Access Compliance Report

Public Rights-of-Way

(Curb Ramps)

Intersection ID: 10038838	Main Street: STEELECROFT_PY	Cross Street: N/A	Location: W
ADA ID: D1A0A7567FC5	Ramp Type: PerpDiag	Initial Pass/Fail: Fail	Overall Compliance: No
Severity Score: 33.75			
Codes/Mitigation Info/Possible Solution		Field Measurements/Component Compliance

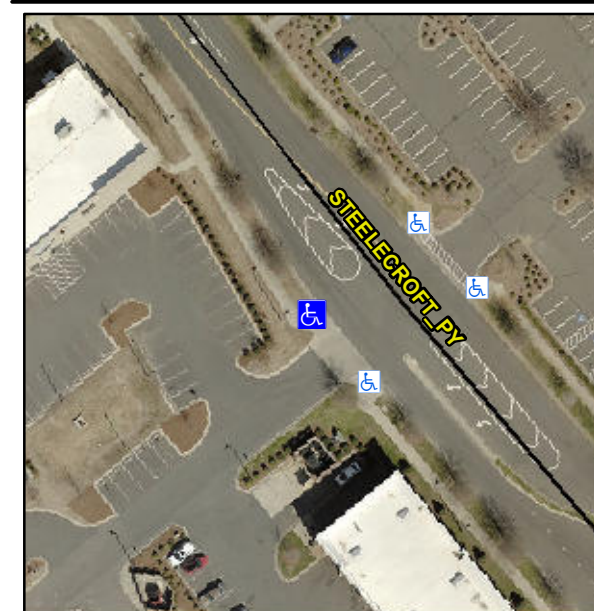
Not Found, R304.5.1, R304.2.2

Compliance	Description	Data	Compliance	Description	Data
N/A	Ramp Length (in)	103.0	No	Ramp Slope (%)	12.8
No	Ramp Width (in)	46.5	Yes	Ramp XSlope (%)	1.5
N/A	Flare Type LT	N/A	N/A	Flare Type RT	N/A
N/A	Flare Slope LT (%)	N/A	N/A	Flare Slope RT (%)	N/A
N/A	Flare Traversable LT?	N/A	N/A	Flare Traversable RT?	N/A
N/A	Landing Length (in)	N/A	N/A	DWS Provided?	N/A
N/A	Landing Width (in)	N/A	N/A	DWS Contrast?	N/A
N/A	Landing Slope (%)	N/A	N/A	DWS Length (in)	N/A
N/A	Landing X Slope (%)	N/A	N/A	DWS Full Width?	N/A
N/A	Landing Curb? (Y/N)	N/A	N/A	DWS Offset (in)	N/A
N/A	Shared Landing?	N/A			
N/A	Gutter Ponding?	N/A	N/A	Gutter Slope (%)	N/A
N/A	Gutter Lip Ht (in)	N/A	N/A	Gutter X Slope (%)	N/A
N/A	Painted X Walk1?	No	N/A	Painted X Walk2?	No
	X Walk 1 Direction	To SE		X Walk 2 Direction	To NE
N/A	X Walk 1 Width (in)	N/A	N/A	X Walk 2 Width (in)	N/A
	X Walk 1 Slope (%)	0.7		X Walk 2 Slope (%)	1.5
	X Walk 1 X Slope (%)	3.7		X Walk 2 X Slope (%)	1.3

Remove & Replace Curb Ramp With Two New Directional Ramps or Equivalent.
